CITY PLANNING COMMISSION

- APPLICATION:
1. Negative Declaration
 2. Amend the 1963 Oak Park Community Plan from Light Density Residential to Medium Density Multiple Family for 0.1± vacant acres
 3. Rezone 0.1± vacant acres from Limited Commercial (C-1) zone to Medium Density Multiple Family (R-4) zone
 4. Tentative Map to divide 0.1± vacant acres into a four-unit airspace condominium lot
 5. Special Permit to develop a four-unit condominium project

LOCATION: Northeast corner of 24th Street and Castro Way

PROPOSAL: The applicant is requesting the necessary entitlements to develop a two-story, four-unit condominium project.

001778
FRONT ELEVATION
24th STREET

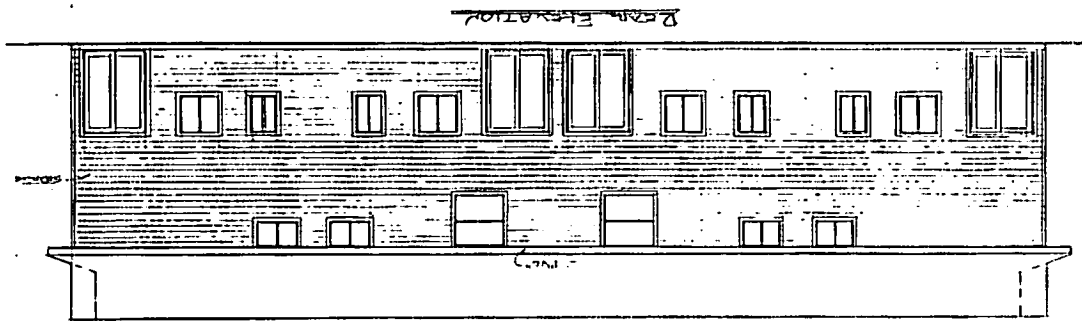
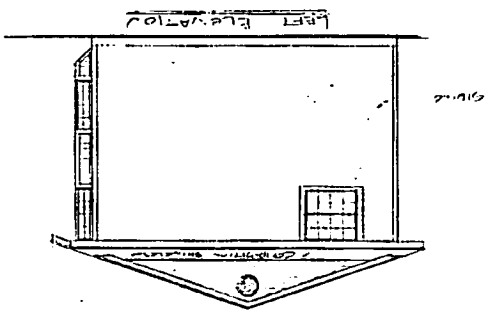
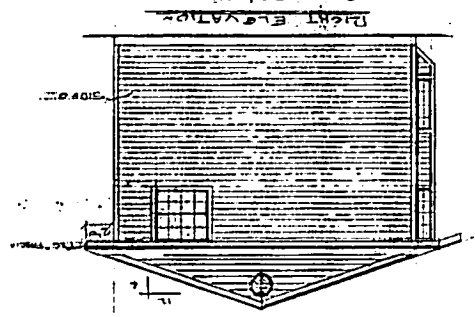
4. Staff has concerns with regard to the flat, unbroken design of the structure's south and north elevations. In order to provide visual interest and design continuity with the west elevation, staff suggests the addition of bay window treatments for the south and north elevations. Additional windows are recommended for the first and second floors on the west elevation between the two sets of vertical column of bay windows. The applicant's architect should consult with City staff with regard to specific design modifications.

- c. The applicant shall consult with City staff regarding specific design and elevation modifications to the project. The final plans shall be submitted to City staff for review and approval prior to the issuance of building permits. These design changes shall include the following:

- 1) addition of bay window treatments on the south and north elevations;
 - 2) additional window openings on the first and second floors of the west elevation between the two sets of bay windows;

- 3) change the front doors from the flat surface to paneled surface doors.
- d. Detailed landscaping and irrigation plans shall be submitted for review and approval by City staff prior to issuance of building permits.
